# SERVICE BULLETIN

Service Bulletin No.: DA20-77-01, Rev. 0

Title: Tachometer, Cable Assembly, Inspection.

FIGURE 1.

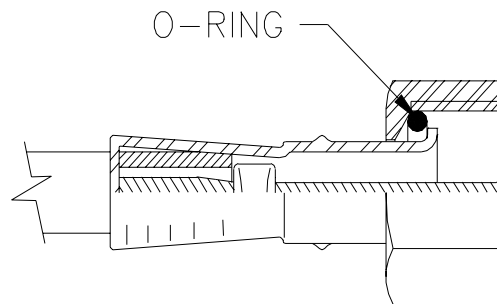
11.1.4 Ensure that the O-Ring is installed at the Engine end of the cable.

FIGURE 3.

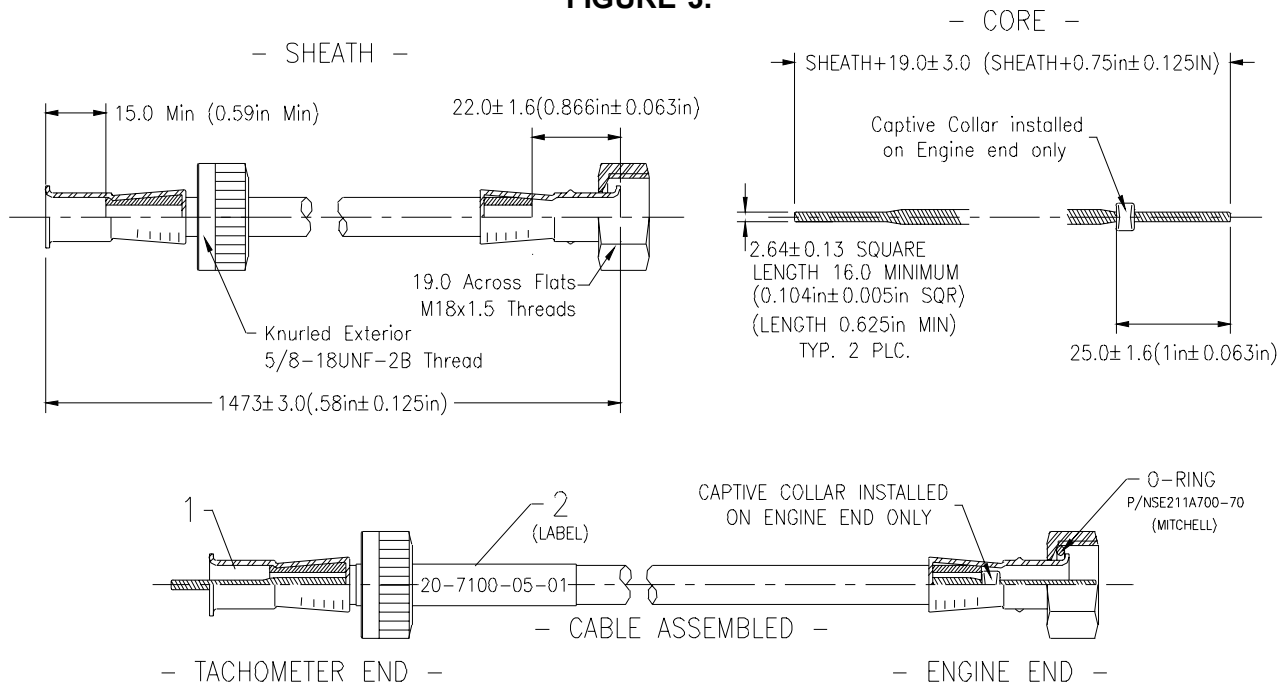
11.1.9 If the above items are O.K., install an identification sleeve at the instrument end of the Cable. (See Figure 3).
